# PLAN COMMISSION

Wednesday, April 10, 2024 – 6:30 PM

- B. Review/Recommendation: Plan Commission review & recommendation on a Conditional Use Application submitted by Kunes Appleton Properties for a proposed addition to the existing heavy vehicle sales and rental principal building located at 2615 West American Drive, specifically described as Tax ID #006-0341-01.

- C. Review/Recommendation: Plan Commission review & recommendation on a Site Plan Application submitted by Kunes Appleton Properties for a proposed addition to the existing heavy vehicle sales and rental principal building located at 2615 West American Drive, specifically described as Tax ID #006-0341-01.

**C1.4A** 45

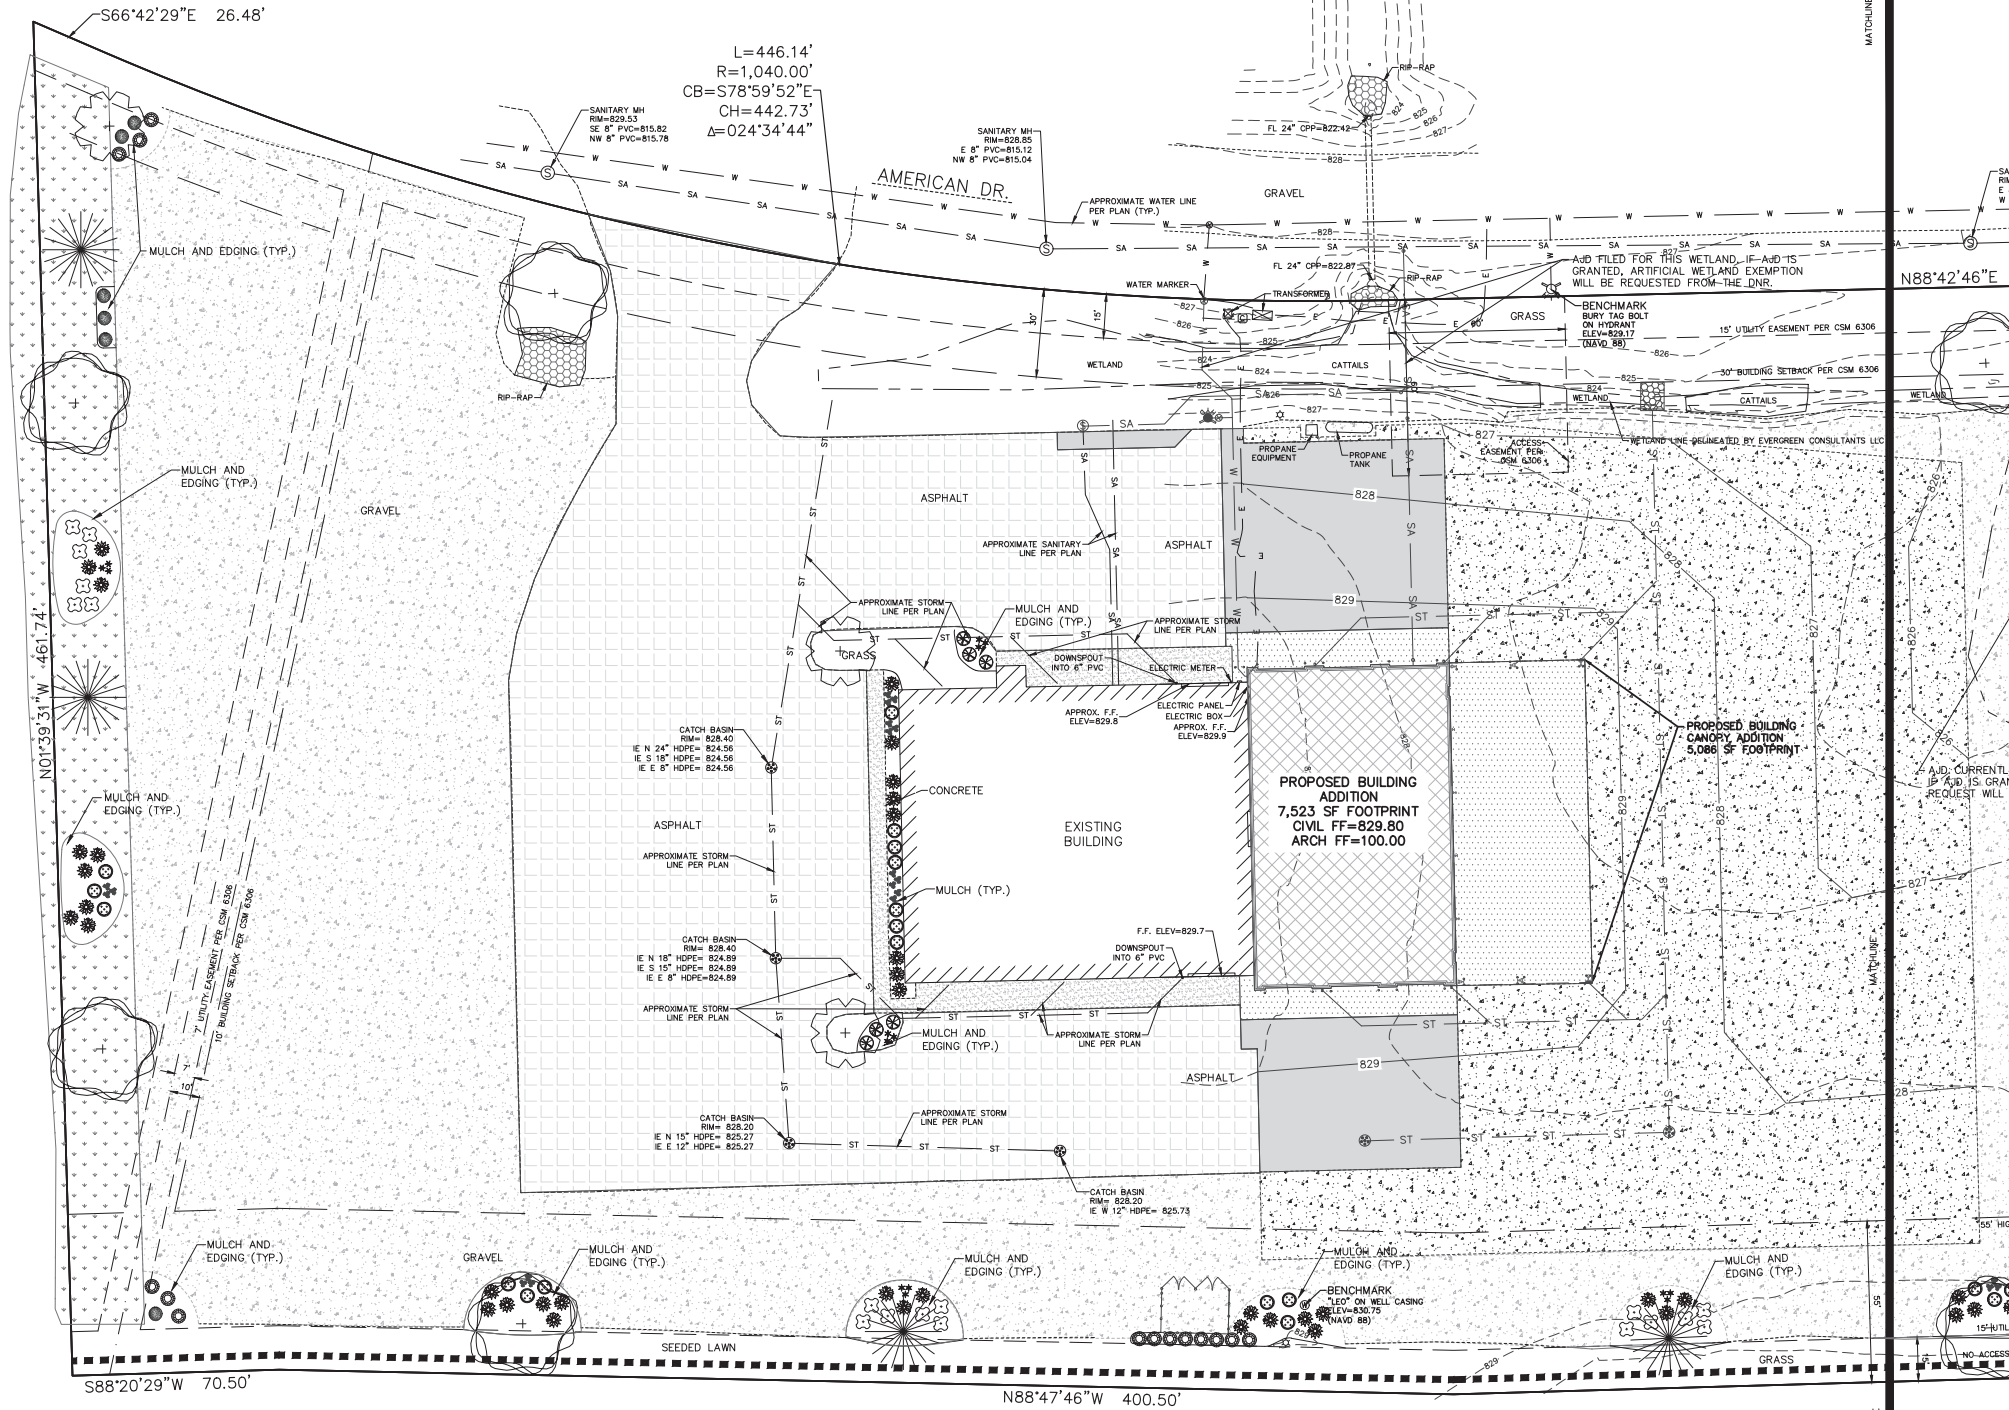
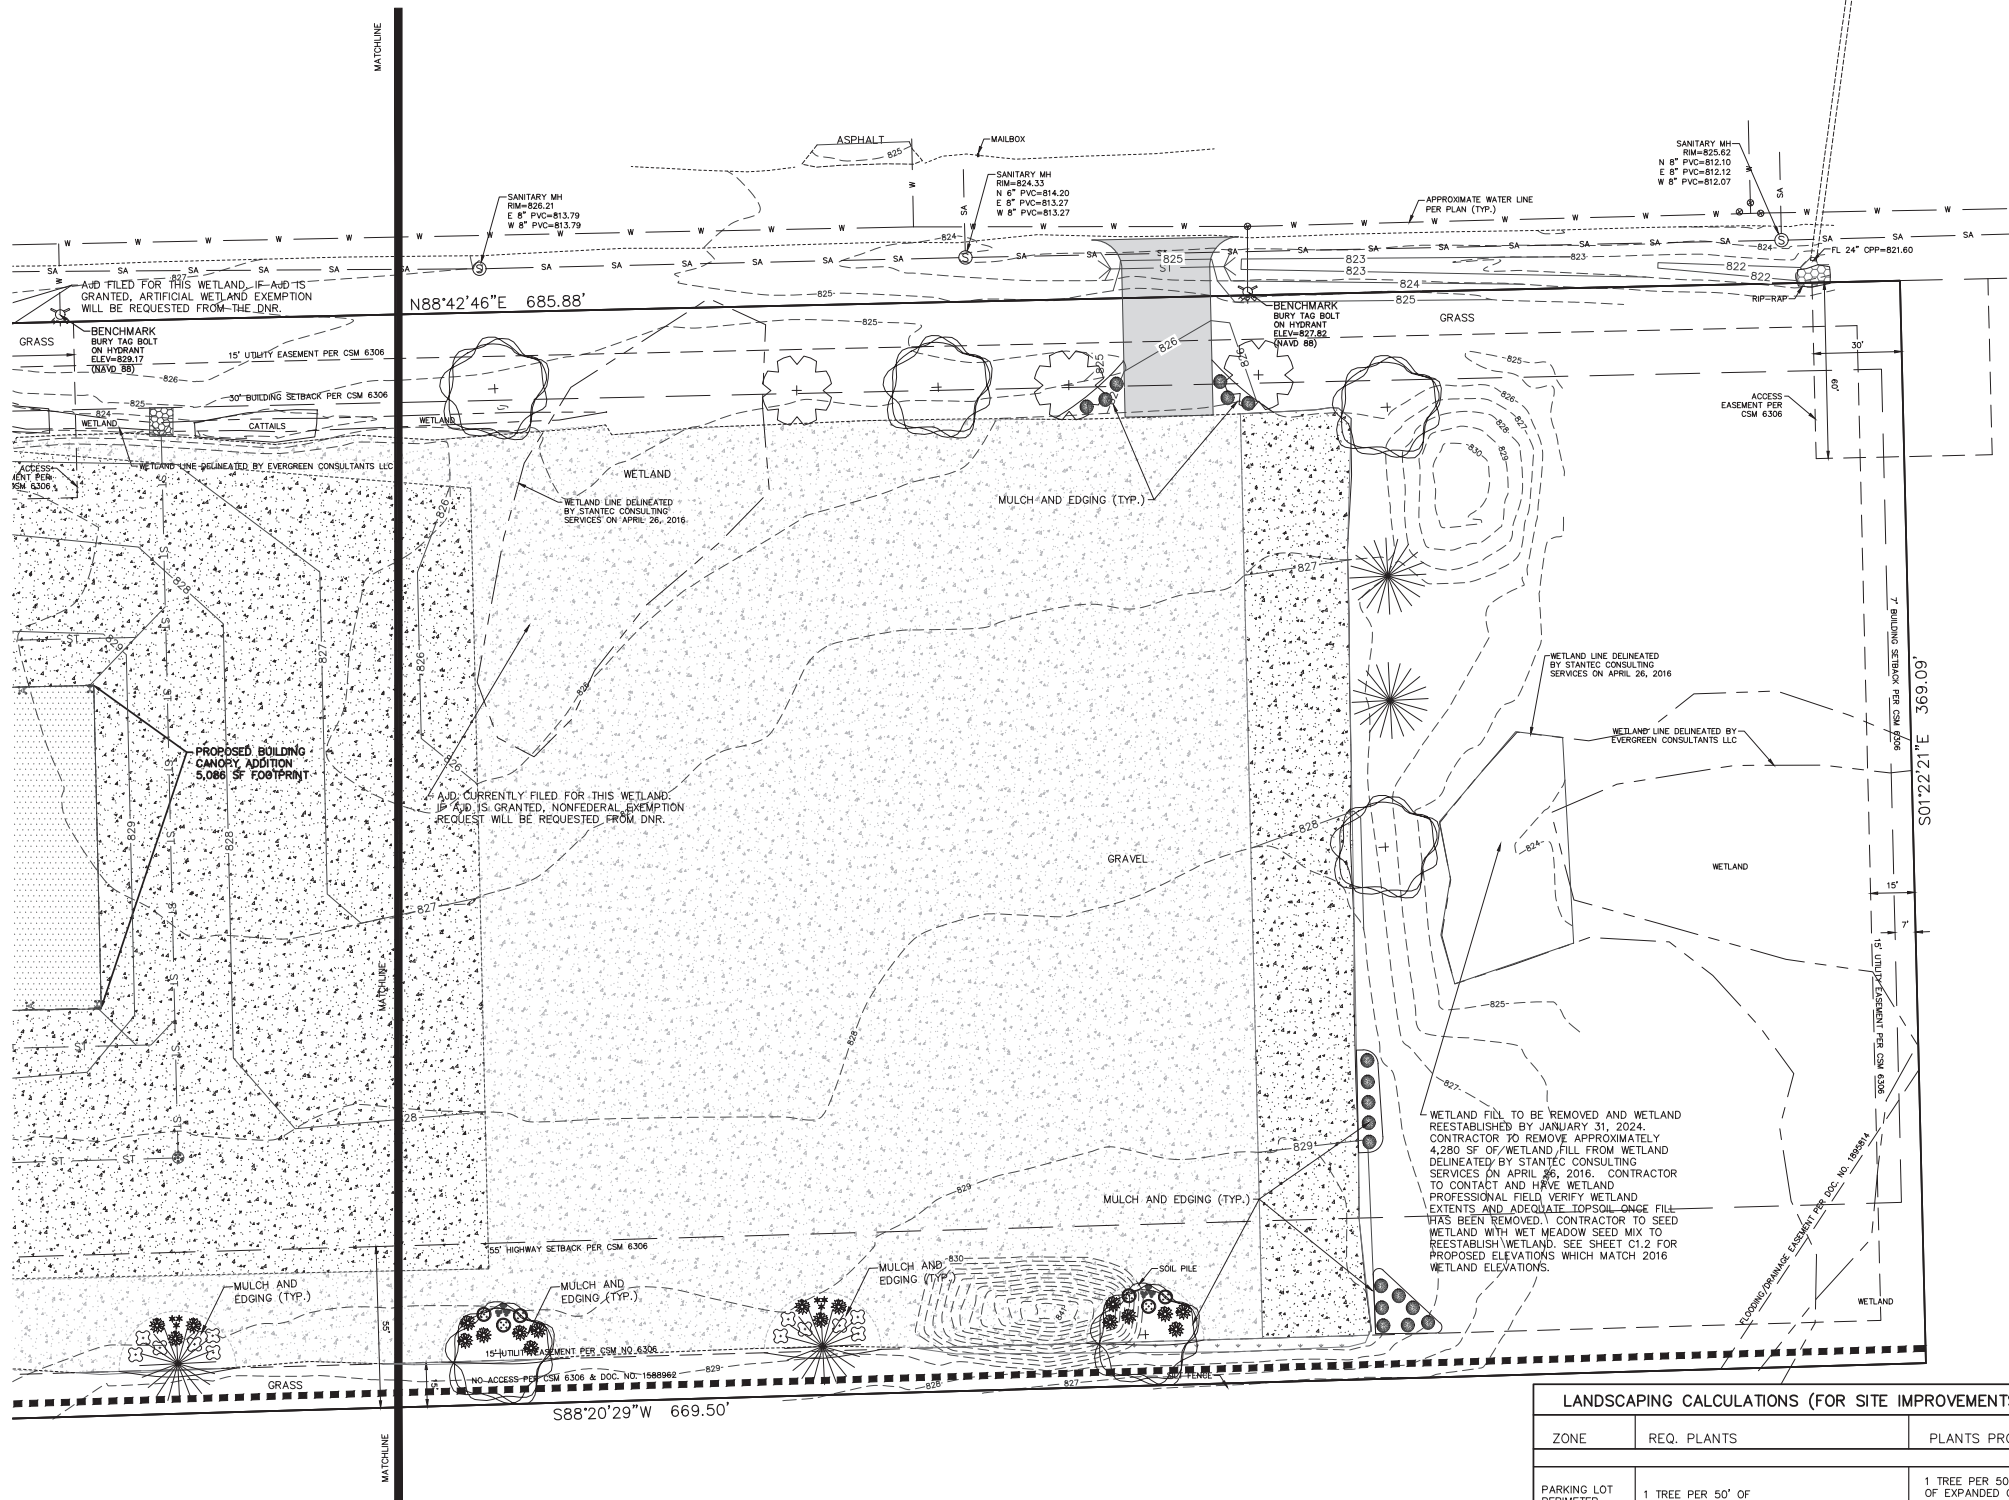
7. Applicant submitted a landscape plan which appears to adequately address the 2017 Site Plan Approval landscaping and adequate landscaping for the proposed building addition and outdoor display area expansion except building landscaping.

- Plan Commission will need to determine if the proposed landscaping plan is adequate and may be approved as proposed.

**Excel Response:** Landscape plan now provided as sheet C1.4, maintaining consistency with the 2017 Site Plan approval.

COLORED ELEVATIONS

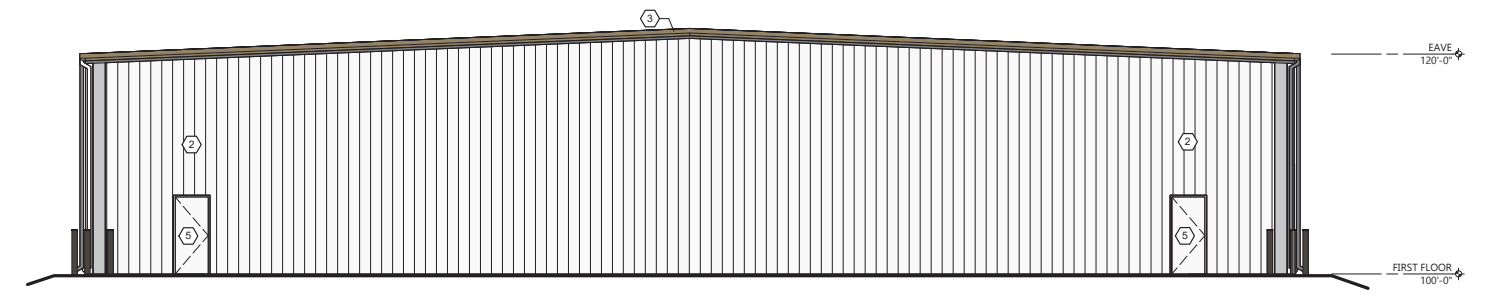
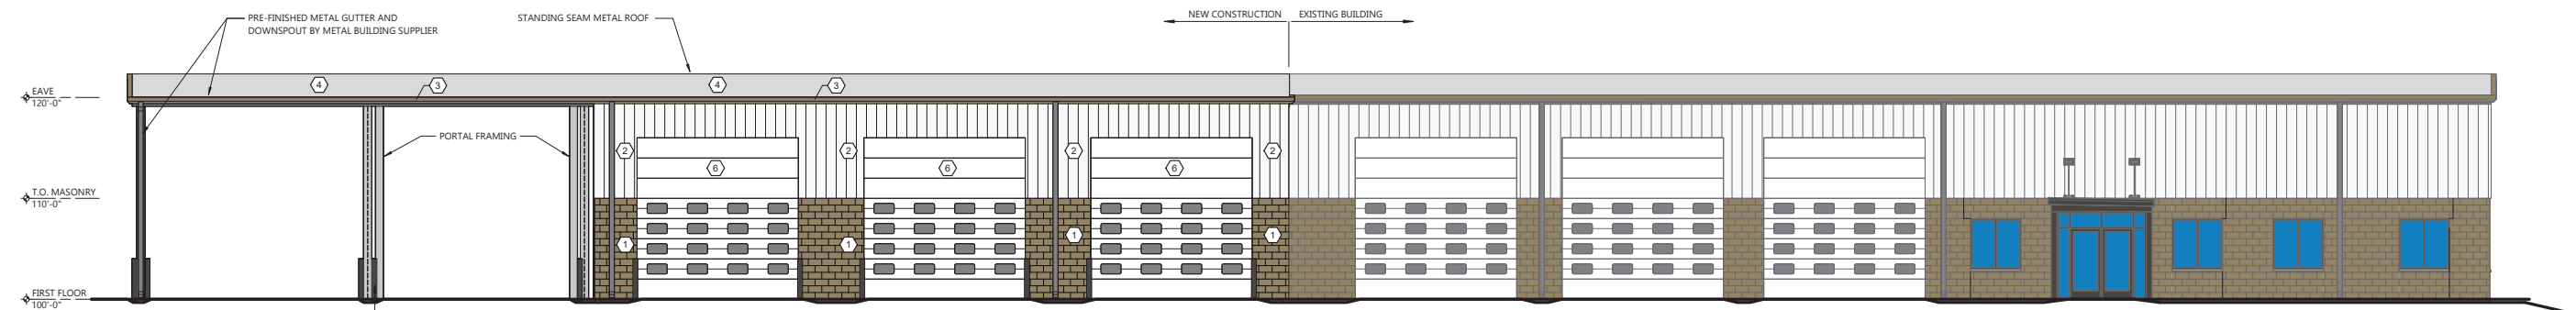
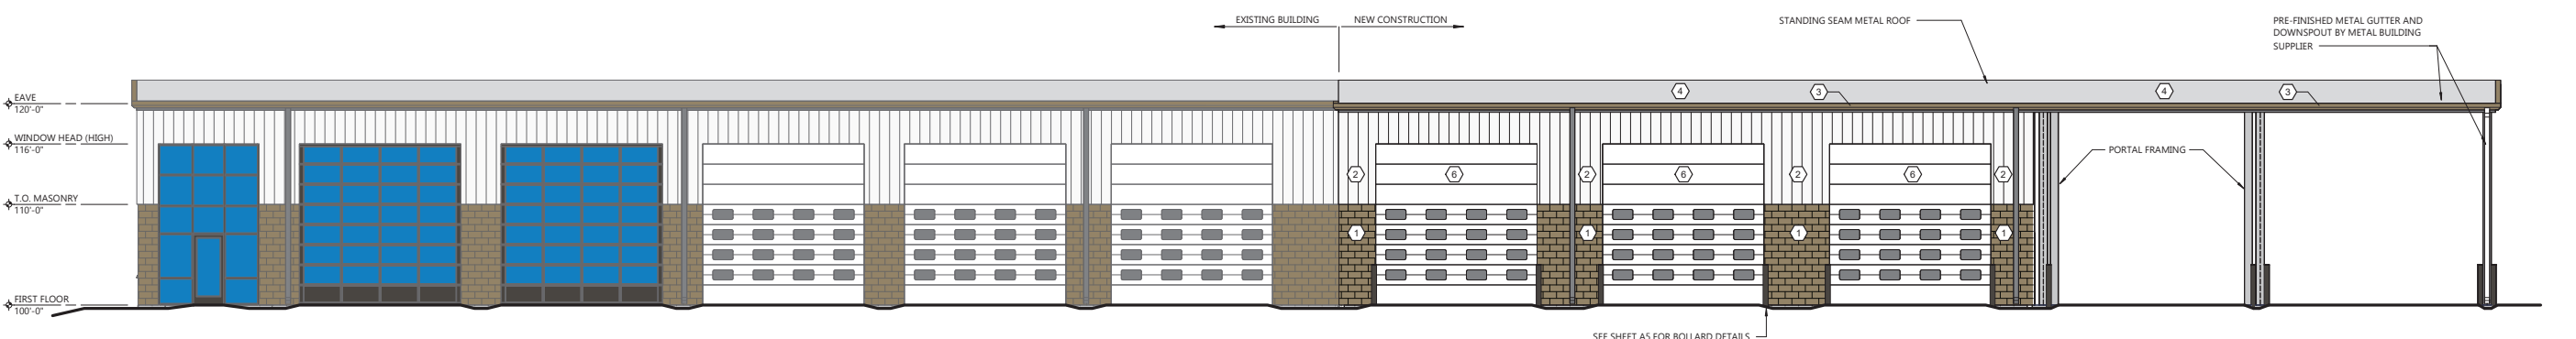
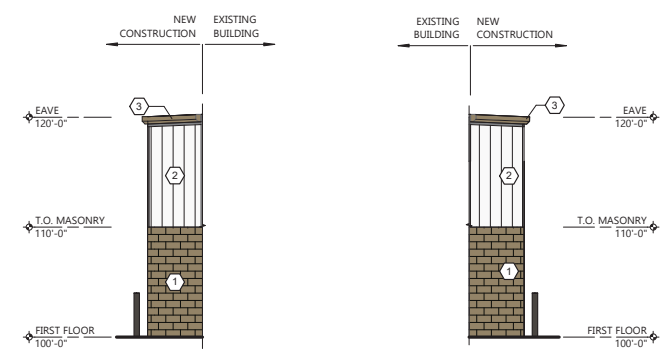
Although the applicant did not provide area calculations identifying the percentage of exterior wall surfaces covered with “acceptable exterior building materials”, it is apparent that 75% of all exterior wall surfaces of the proposed addition are not covered with “acceptable exterior building materials” and the proposed exterior wall materials do not comply with the requirements of Sec. A. (2) (a).

- *Except as provided below, loading docks and overhead doors shall be located in the side yard or rear yard and shall not be located facing a street yard.*  
**Overhead doors are proposed on both street-facing sides of the building, facing USH 10 and West American Dr.**
- *Should the building orientation or parcel not provide a suitable accommodation or present an undue hardship for locating loading docks and overhead doors in and/or facing the side or rear yard, the Town Board may allow loading docks in and/or facing the street yard if a practical alternative does not exist.*

4. The proposed exterior wall materials do not comply with the requirements of Attachment C for the Tier 1 architectural design zone (i.e., “Acceptable Exterior Building Materials” shall cover at least 75% of all exterior wall surfaces of the proposed addition).
  - Plan Commission will need to determine if compliance with the exterior wall materials requirements of Attachment C will be required for the proposed addition or if Plan Commission will recommend allowing the percentages of Acceptable Exterior Building Materials to be decreased for consistency in architectural design of the existing building.

The applicant provided the following response to this issue: *“To maintain architectural consistency and provide a uniform building, exterior building materials consistent with the existing building materials are proposed.”*

The applicant provided the following response to this issue: *“To maintain architectural consistency and provide a uniform overhead door layout, overhead doors are proposed on the north and south sides of the proposed building addition.”*

**Excel Response:** To maintain architectural consistency and provide a uniform building, exterior building materials consistent with the existing building materials are proposed.
